# THE WICHITA AIRPORT AUTHORITY WICHITA, KANSAS MID-CONTINENT AIRPORT

## PLANS FOR PROPOSED CESSNA MX FACILITY FOR: FLIGHT SAFETY INTERNATIONAL

DRAINAGE IMPROVEMENTS  
PRIVATE PROJECT NO. 0043 PPD 16078611

AS BUILT PLANS	
CONTRACTOR:	McCullough Excavation
INSPECTOR:	Ryan McCullough P.E., McCullough Excavation
PDF BY:	RDM 12-05-2011

SHEET NUMBER  
**C3.1**  
NORTH GRADE PLAN

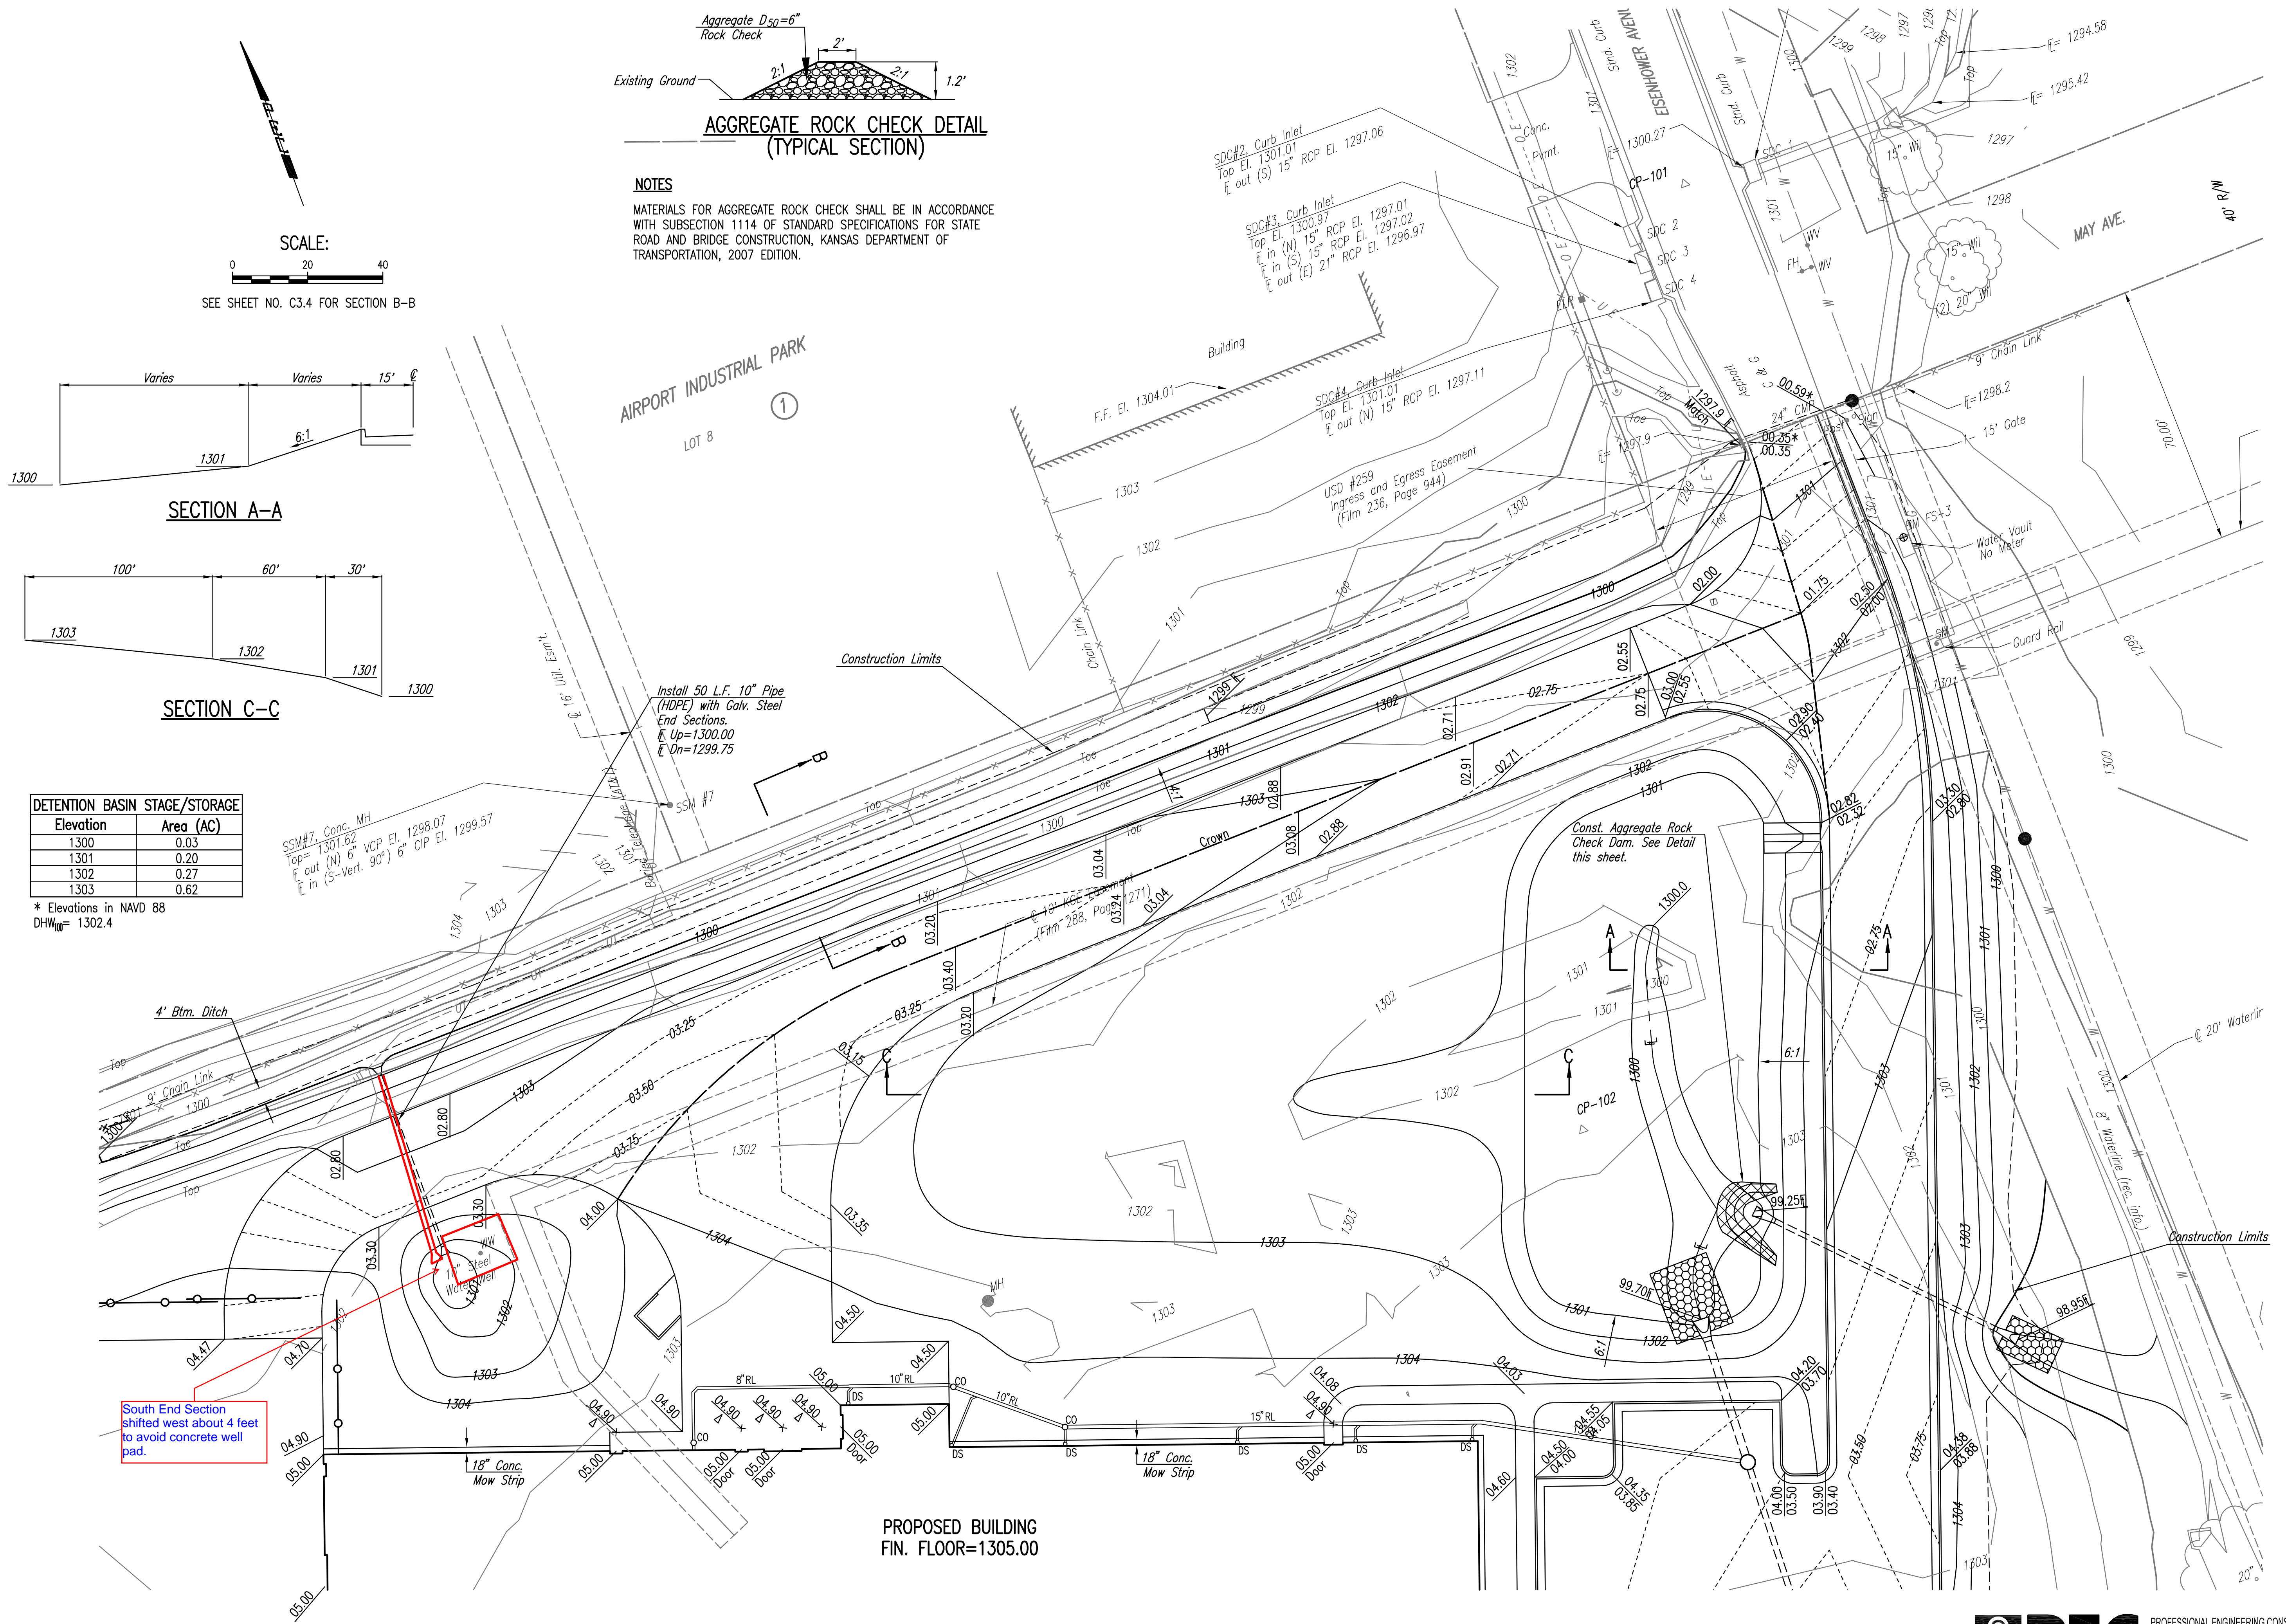
South End Section shifted west about 4 feet to avoid concrete well pad.
